Morgan Offshore Windfarm Generation Assets Case Team
Planning Inspectorate
morganoffshorewindproject@planninginspectorate.gov.uk
(Email only)

MMO Reference: DCO/2022/00003
Planning Inspectorate Reference: EN010136
Identification Number: 20048964

Planning Act 2008, BP Alternative Energy Investments Ltd, Proposed Morgan Offshore Windfarm Generation Assets Order

Deadline 2 Submission

Figure 1: Plot showing the relationship between distance and received SEL for the north transect, for the maximum piling energy of 4,400 kJ.

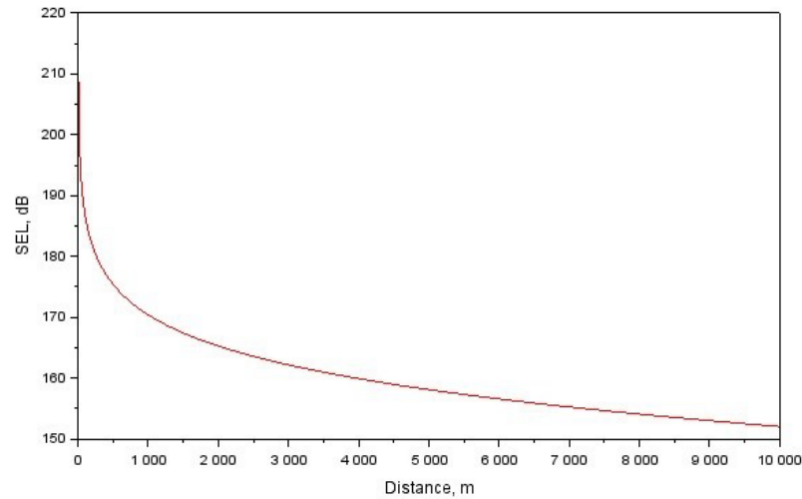
RR-020.79	As previously requested at PEIR stage, the MMO requests that a received level versus range curve/plot for a given transect be provided in Volume 3, Annex 3.1.	Please see below Figure 1 showing the received SEL against distance from the source.	The MMO thanks the applicant for providing clarification on this matter and has no further comments to add at this time.
